Site Plan Application

Hudson Planning Commission	SITE PLAN REVIEW
Case No. 2021-1166	November 8, 2021

RAMCO SPECIALTIES
2021 EXPANSION
5445 HUDSON INDUSTRIAL PKWY, HUDSON, OH

Re: **5445 Hudson Industrial Pkwy - Ramco Addition**
Preliminary Engineering Approval - Viewpoint #21-1166

PHOTOMETRIC PLAN

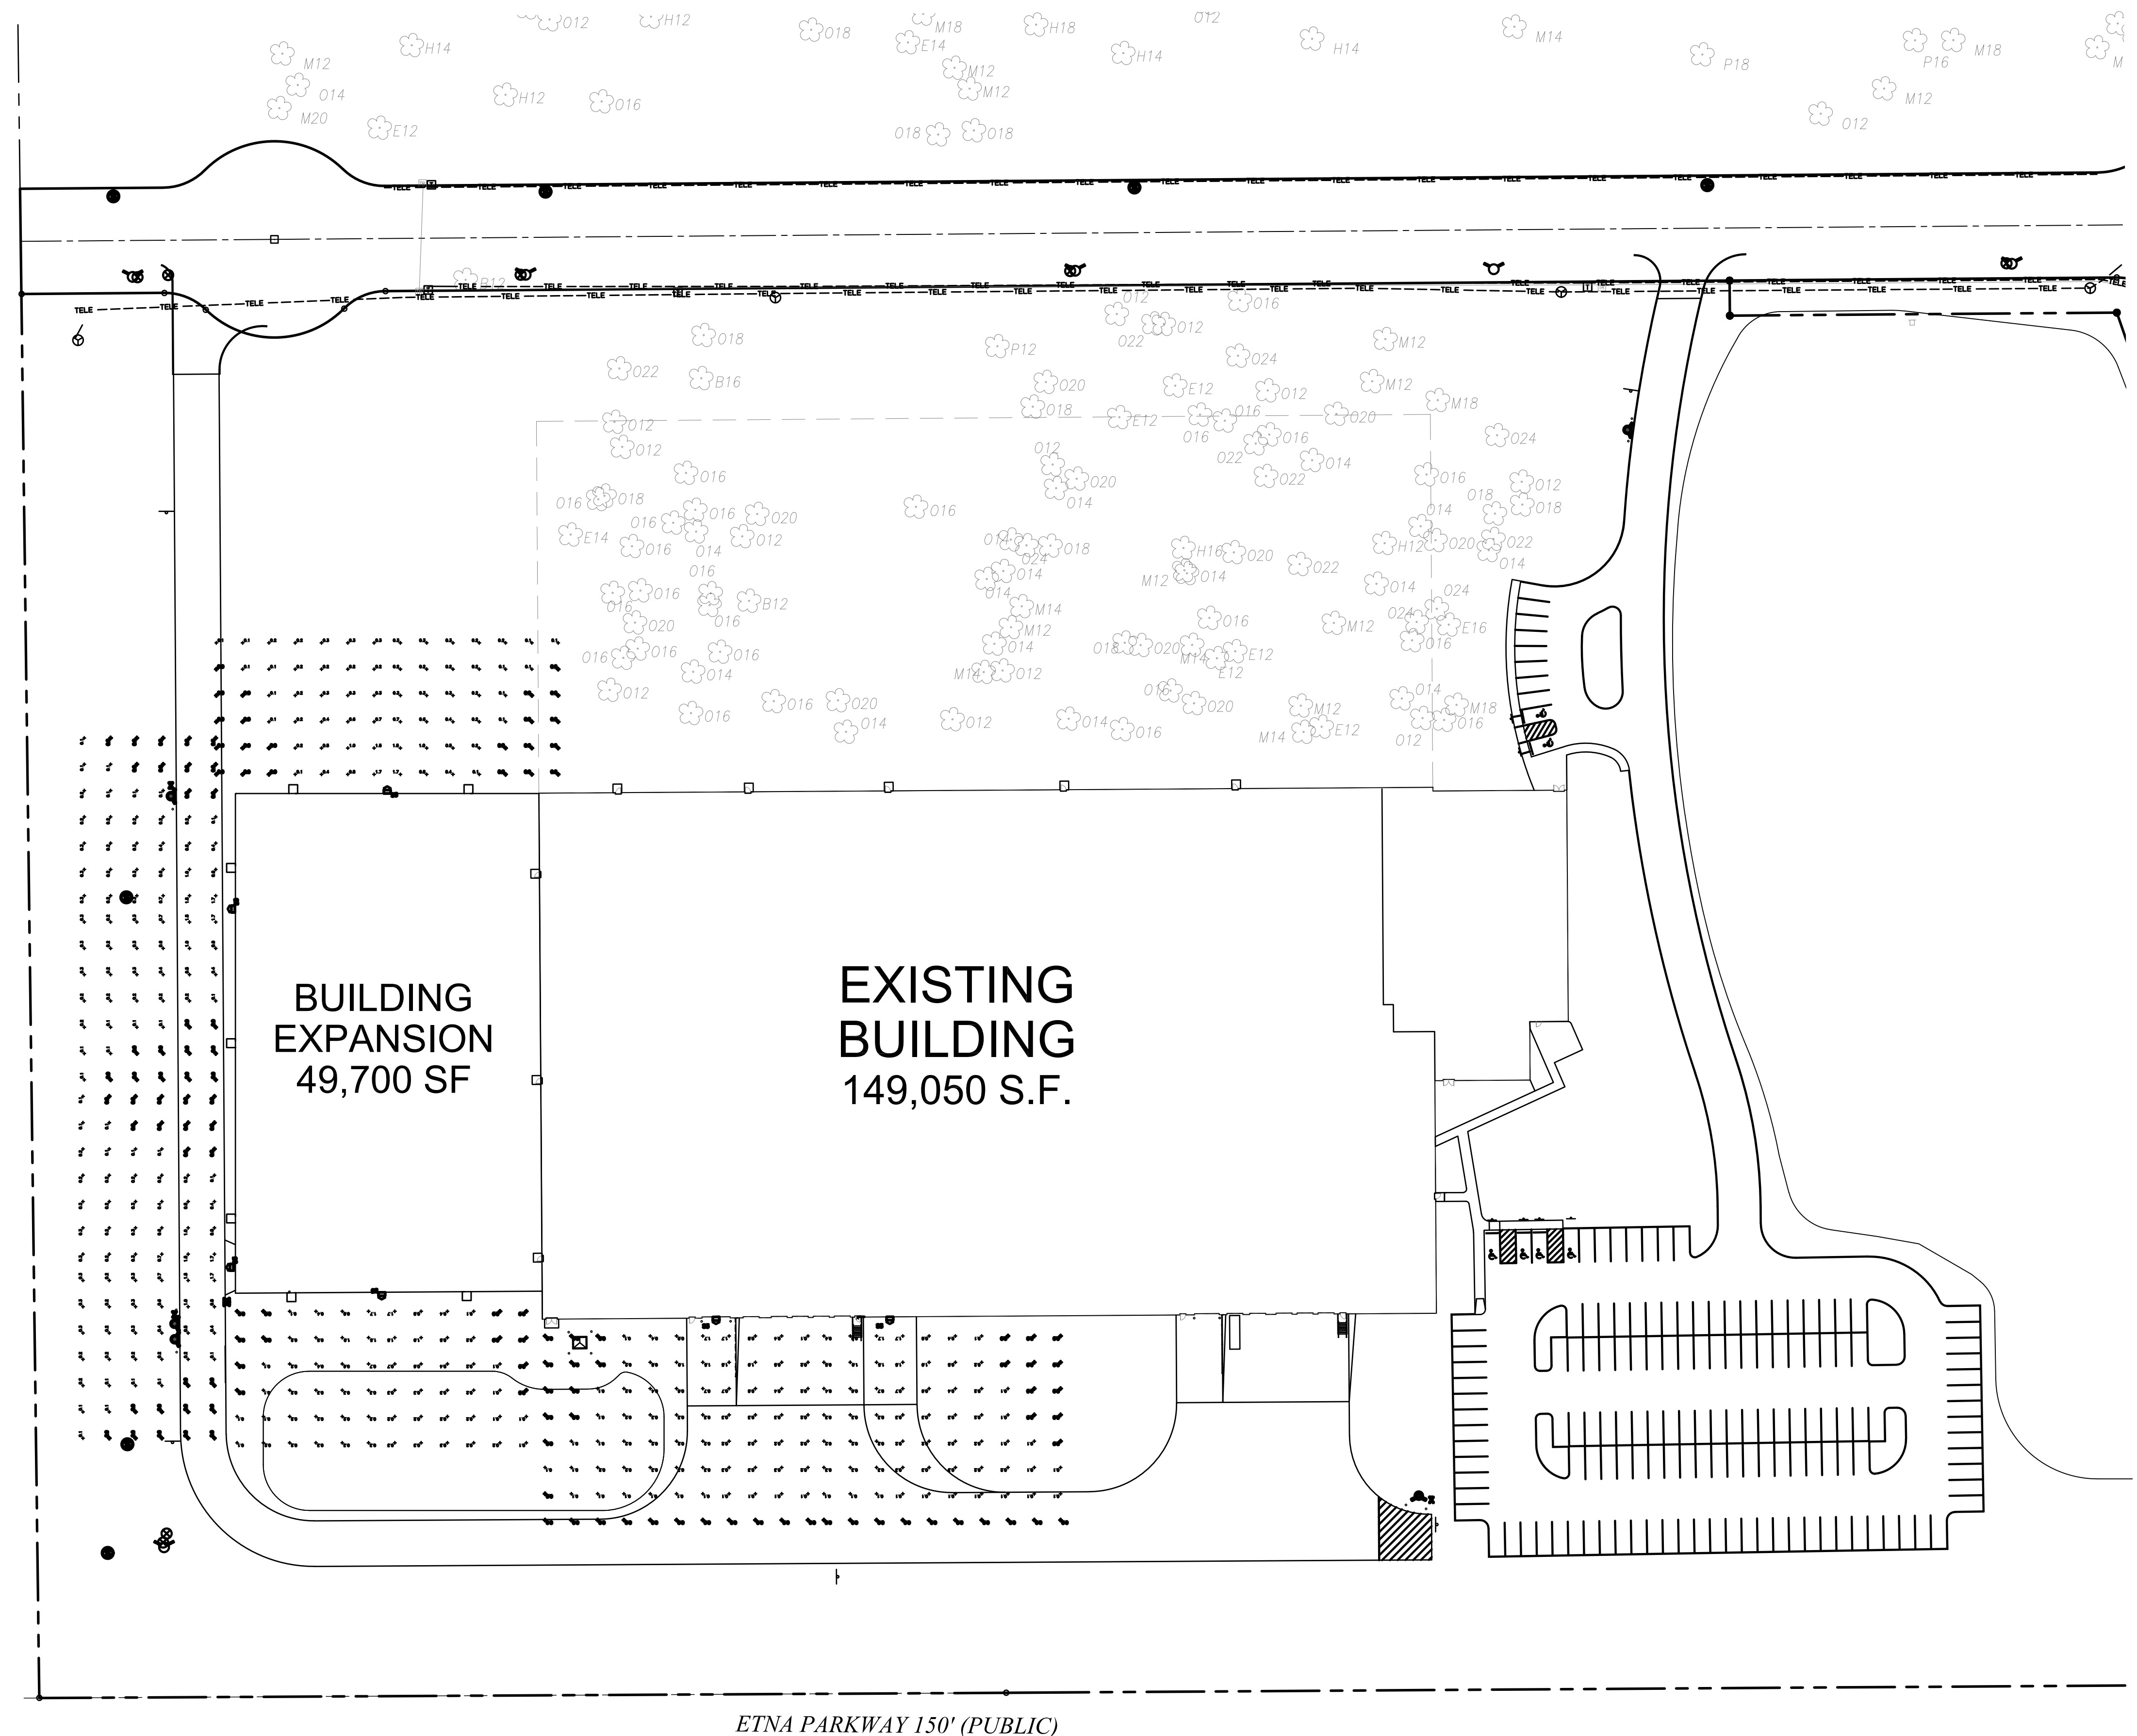
- ☒ **Exterior Lighting** The applicant has submitted a photometric plan with proposed lighting levels in compliance with the Land Development Code. The proposed addition would be illuminated by a series of LED wall packs.
